# UNITED STATES PATENT AND TRADEMARK OFFICE

APPLICATION NO.	FILING DATE	FIRST NAMED INVENTOR	ATTORNEY DOCKET NO.	CONFIRMATION NO.
10/720,173	11/25/2003	Eun-Bong Han	102-1003	4330
38209	7590	12/16/2005		
STANZIONE & KIM, LLP 919 18TH STREET, N.W. SUITE 440 WASHINGTON, DC 20006			EXAMINER	LIANG, LEONARD S
			ART UNIT	PAPER NUMBER
			2853

<b>Office Action Summary</b>	Application No.	Applicant(s)
	10/720,173	HAN, EUN-BONG
	Examiner	Art Unit
	Leonard S. Liang	2853

## **DETAILED ACTION**

FIG. 1  
(PRIOR ART)

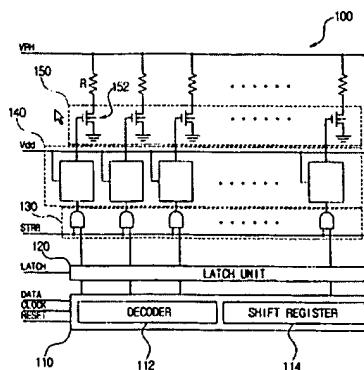
- {claim 1} An inkjet printer head driving apparatus having a plurality of heating elements and nozzles (figure 1, reference 100); a switching unit turning on and off each of the heating elements to heat ink corresponding to selected nozzles to eject the ink (figure 1, reference 150); a level shift unit having a level converter converting a potential level of a signal inputted therein into a predetermined potential level to drive the switching unit, and a transient time extending part

provided with at least one time extending element to extend by a predetermined time a transient time during which the potential level of the signal inputted from the level converter to the switching unit is converted from a first signal level to a second signal level and vice versa (figure 1, reference 150; while it is appreciated that the admitted prior art does not include a transient time "extending part" as characterized later by applicant's specified invention, the examiner considers that the claimed invention here is sufficiently broad to be able to be read on by the disclosure of the admitted prior art in paragraph 0012 of the specification. In such a broad recitation, the delay of the output voltage of the level converter is seen to correspond to a transient time extension. As seen below, later claims that further describe the nuances of the transient time extending part, as characterized by the applicant's specified invention are objected to as being allowable); a control unit receiving an external data signal, decoding the received data signal, and outputting the decoded data signal as a nozzle selection signal to the level shift unit to select the selected nozzles corresponding to a to-be-recorded image from the nozzles (figure 1, reference 110)

- {claim 8} An inkjet printer head driving apparatus having a plurality of heating elements and nozzles (figure 1, reference 100); a control unit generating a control

nozzle selection signal to select a heating element and a nozzle corresponding to an image to be printed (figure 1, reference 110); a level shift unit generating a first nozzle selection signal having a first transient time, during which a level of the first nozzle selection signal is changed between first and second levels, in response to the control nozzle selection signal, and generating a second nozzle selection signal having a second transient time extended by a period from the first transient time (figure 1, reference 140); and a switching unit turning on and off the heating element according to the second nozzle selection signal (figure 1, reference 150)

- {claim 10} wherein the switching unit comprises a transistor having a first terminal coupled to the level shift unit, a second terminal coupled to the heating element, and a third terminal connected to a potential, and the residual voltage of the switching unit is a voltage of the first terminal (figure 1, reference 150)
